# 1990 Corvette: Service Bulletin: SIR Diagnostics and Procedures to Prevent Codes 16 and 26 Due to Corrosion Revised

**Subject:** SERVICE MAN. UPDATE SEC.9J A/B REV. SIR DIAGNOSTIC PROCEDURE

**Model and Year:** 1990 CORVETTE

**Bulletin Number:** 90-436-9J - (11/07/1991)

#### FORWARD DISCRIMINATING SENSORS Figures 1 & 2 -----

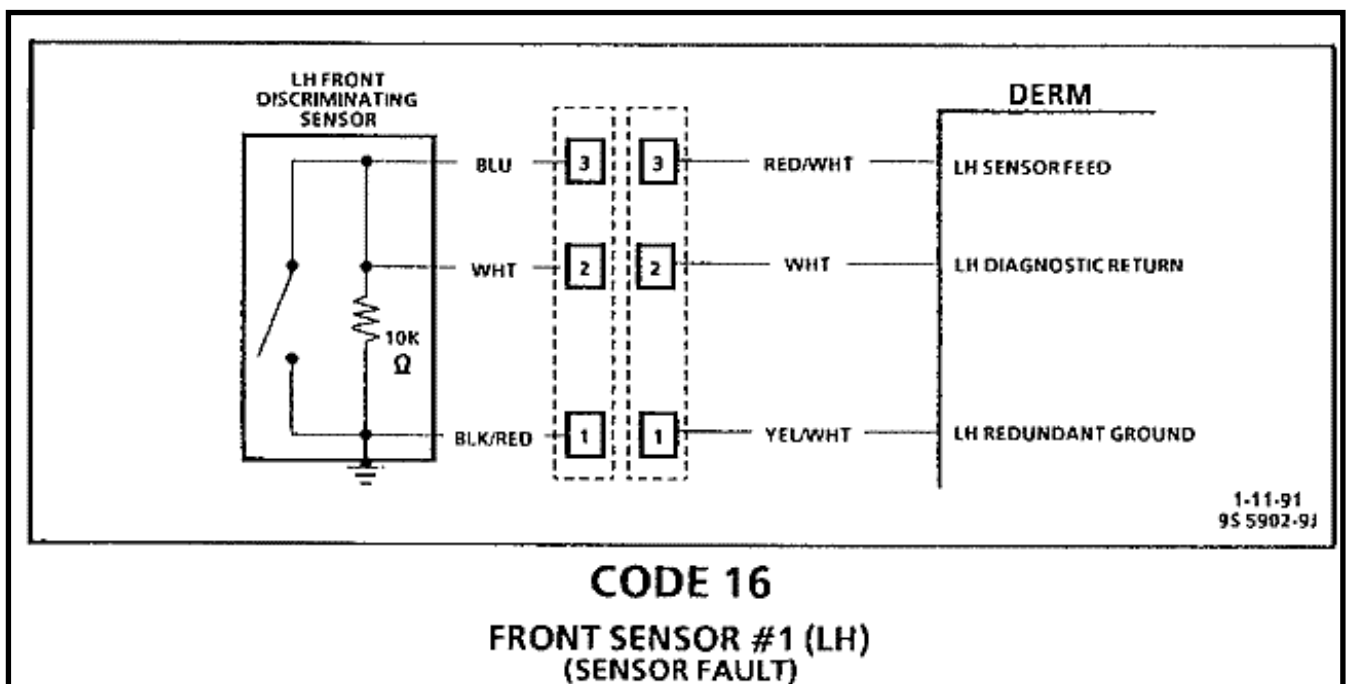
Caution should be used to assure proper location of sensors to the front frame rails. The keying of the sensors to the frame rails through the differently sized mounting bolt holes in the sensor mounting plate should never be modified in the field.

1. Apply a thin layer of special grease P/N 12345579 to the frame rail mounting surface and the mounting flange of the sensor. Do not apply the grease to the mounting bolts or holes.
2. Forward discriminating sensor, with arrow pointing toward front of vehicle.
3. External tooth lock washers, P/N 11501869 (8 mm) and 121753 (6 mm) to mounting bolts.
4. Sensor mounting bolts. Ensure that washers are between bolt head and sensor mounting flange, not between mounting flange and frame rail.

- Proper operation of the forward discriminating sensor requires the sensor be rigidly attached to the vehicle structure and that the arrow on the sensor be pointing toward the front of the vehicle.

1. Apply a thin layer of special grease P/N 12345579 to the frame rail mounting surface and the mounting flange of the sensor. Do not apply the grease to the mounting bolts or holes.
2. Forward discriminating sensor, with arrow pointing toward front of vehicle.
3. External tooth lock washers, P/N 11501869 (8 mm) and 121753 (6 mm) to mounting bolts.
4. Sensor mounting bolts. Ensure that washers are between bolt head and sensor mounting flange, not between mounting flange and frame rail.

- Front (13 mm head) bolt to 25 N.m (19 lb. ft.) - Rear (10 mm head) bolt to 14 N.m (125 lb. ft.)
5. Sensor electrical connection, then clip completed connection into retainer.
  6. Position windshield washer reservoir; install retaining bolts.

## CODE 16 FRONT SENSOR #1 (LH) (SENSOR FAULT)

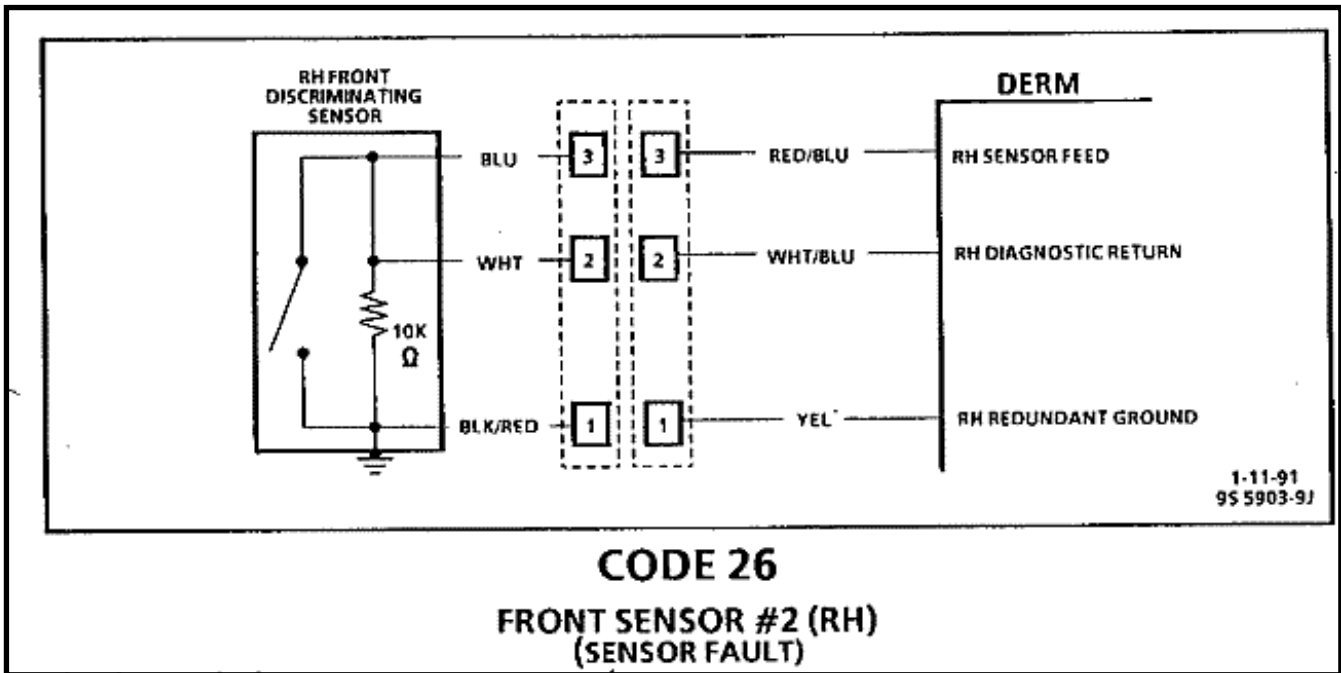
- 3
- REMOVE SENSOR; REFER TO "LEFT SENSOR" ON ATTACHED PAGES.
  - CLEAN ANY PAINT AND/OR CORROSION FROM SENSOR AND FRAME RAIL MOUNTING POINTS AND MOUNTING BOLTS.
  - INSTALL SENSOR; REFER TO "LEFT SENSOR" ON ATTACHED PAGES TO APPLY SPECIAL GREASE AND LOCK WASHERS UPON INSTALLATION TO HELP PREVENT RECURRENCE OF CODE 16 DUE TO CORROSION.
  - CLEAR CODES (TECH 1 PREFERRED).
  - IGNITION "OFF," THEN "ON."
  - DOES CODE 16 RESET?

- 4
- REMOVE SENSOR; REFER TO "LEFT SENSOR" ON ATTACHED PAGES.
  - CLEAN ANY PAINT AND/OR CORROSION FROM FRAME RAIL MOUNTING POINTS AND MOUNTING BOLTS.
  - INSTALL NEW SENSOR; REFER TO "LEFT SENSOR" ON ATTACHED PAGES TO APPLY SPECIAL GREASE AND LOCK WASHERS ON INSTALLATION TO HELP PREVENT RECURRENCE OF CODE 16 DUE TO CORROSION.
  - CLEAR CODES (TECH 1 PREFERRED).
  - IGNITION "OFF," THEN "ON."
  - DOES CODE 16 RESET?
